RE: Florida Crushed Stone Incompleteness/Insufficiency Review  
File Nos. PSD-FL-227 and PA 82-17

RTP Environmental Associates, Inc. (RTP) and the applicant have prepared the following responses to the comments of FDEP's June 16, 1995 memorandum (Attachment 1) regarding the Florida Crushed Stone (FCS) air permit application for the additional cement kiln. These responses are given below in the numbered order in the FDEP memorandum. Responses to the National Park Service letter of June 16, 1995 are given as FDEP response Number 7.

SUBJECT: Florida Crushed Stone  
Incompleteness/Insufficiency Review  
File No. PSD-FL-227 and PA 82-17

**MATERIAL AND GAS FLOW DIAGRAM**

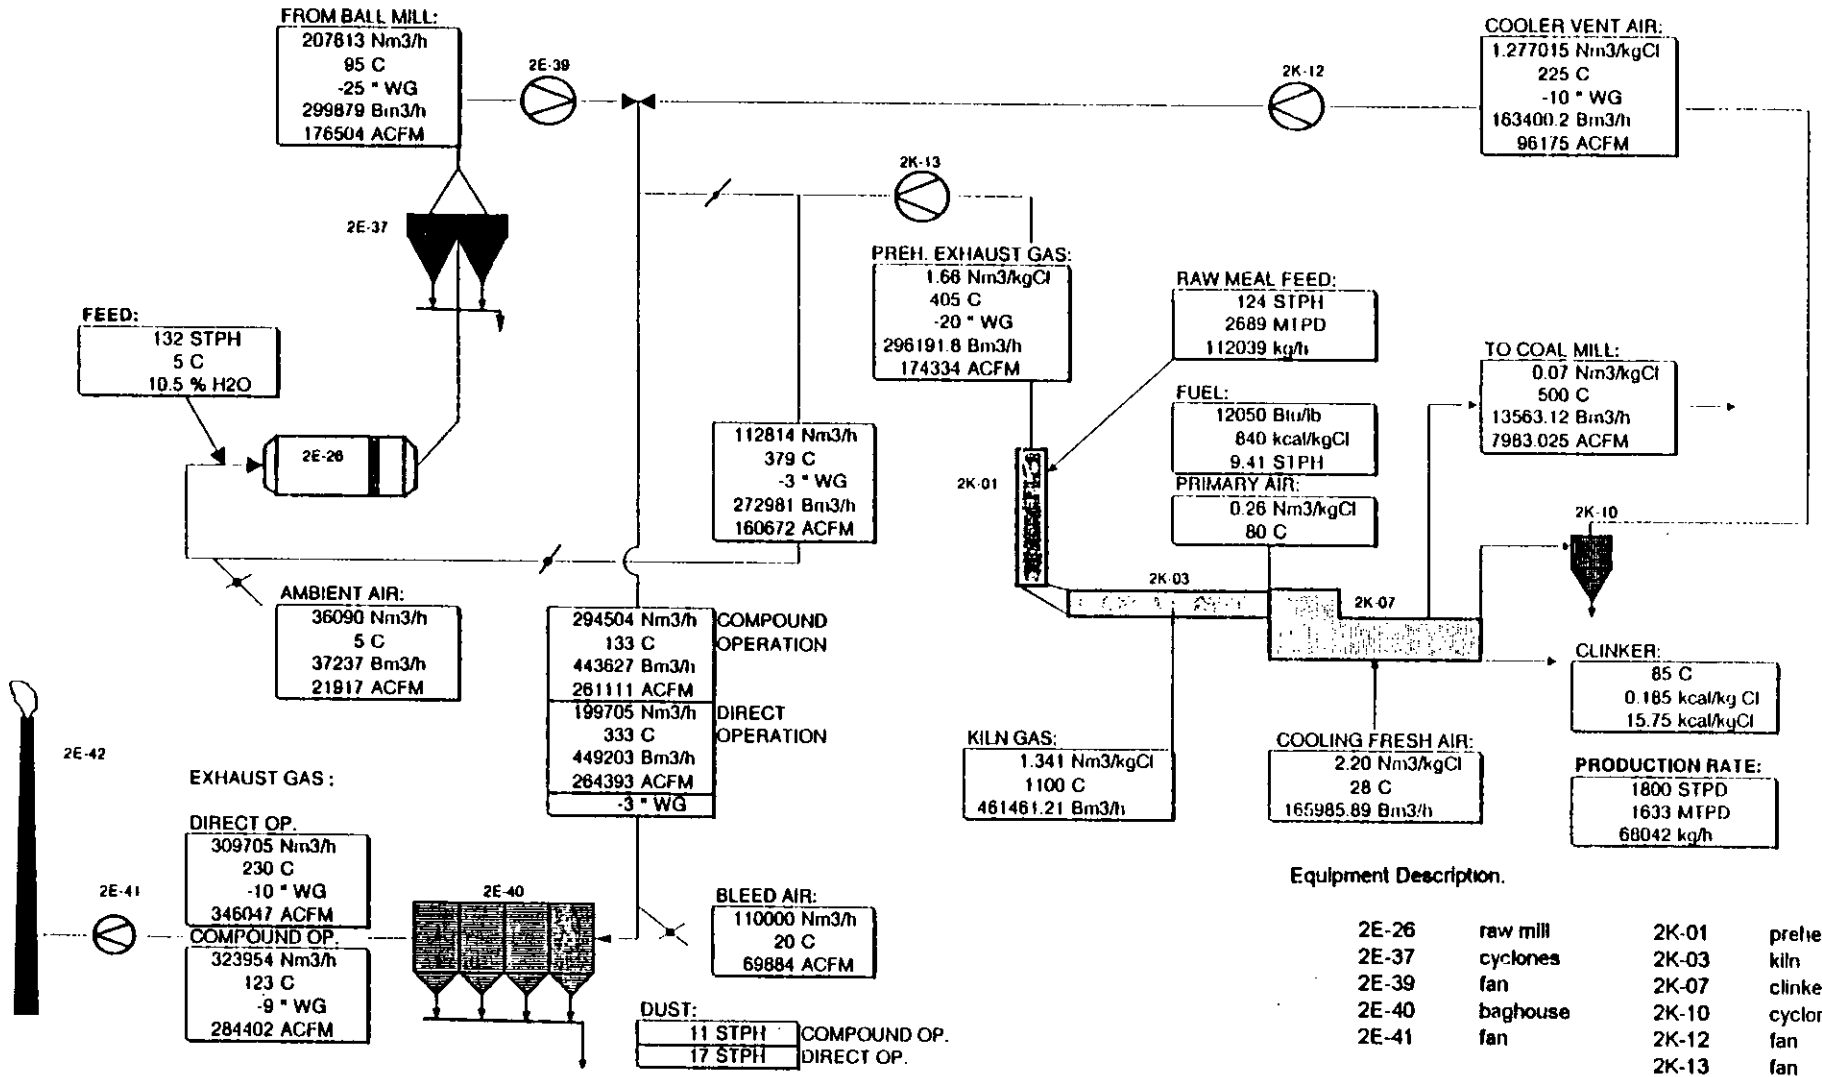
3. Please provide a process diagram of the new kiln which shows all input feeds of gases and materials along with the sources of these feeds. Provide a process diagram of the entire facility including the two kilns and power plant. Indicate whether the raw mill or the dryer for the new kiln will be fired by a combustion source. Provide a description of how the feed material is processed in the existing kiln and state whether any of this processed (heated or dried) material will be utilized in the new kiln.

- 3) Appendix B contains process flow diagrams for the cement plant and the power plant, along with a narrative describing how the feed material is processed in the kiln. In response to the specific question posed in the June 16, 1995 memorandum on combustion in the raw mill and dryer, there is no independent combustion source for the raw mill. The raw mill will utilize the hot gases from the preheater during material processing. In addition, there will be no dryer associated with the new kiln. Tire derived fuel is fed to the kiln at the base of the preheater (kiln inlet).

Attachment B2 presents a material and gas flow diagram for a single cement plant. Operating parameters are for typical actual operating conditions of the facility and are not meant to represent maximum operating conditions of the facility or permit limiting criteria. Two modes of operation are presented in the diagram, compound operation and direct operation. Compound operation describes the operation of the facility when exhaust air from the raw mill is merging with the exhaust air from the kiln and clinker cooler prior to entering the kiln dust collector and exiting the exhaust stack. Direct operation describes the gas flow when the raw mill is not in operation and the only flow out of the exhaust stack is coming from the kiln and clinker cooler exhaust.
